ITU - Telecommunication Standardization Sector Temporary Document 09CC-046

Concord, California, 24 – 28 August 2009

TITLE: **G.hn: PHY-Frame Header Extension**

This contribution proposes a generic PHY-frame header extension scheme to incorporate larger than PHY_H bits in the header (Issue 5.0.1.2.1.0.13). It also proposes not to fix the number of header repetitions (*D*) unconditionally for any given medium since the wide range of bandplans shall be accommodated effectively in a single domain (Issue 5.0.1.2.1.2.0.1).

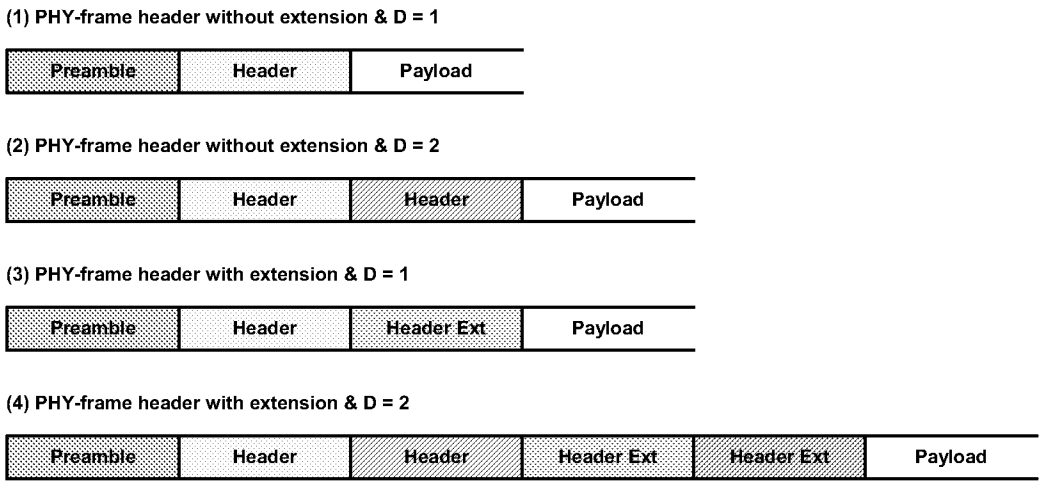
For specifying the number of PHY-frame header repetitions (*D*), we propose not to fix *D* per medium, rather to define a technique to use different values of *D*. Although it is understood that more repetitions may be necessary in coax, fixing *D* unconditionally for any given medium is neither a flexible nor an efficient solution because

- ❑ Applying $D = 2$ uniformly for all bandplans in coax makes G.hn less efficient for wide bandplans (e.g., 200MHz-CRF) as well as over the legacy system.

The possible cases of PHY-frame header transmissions are shown in the following figure.
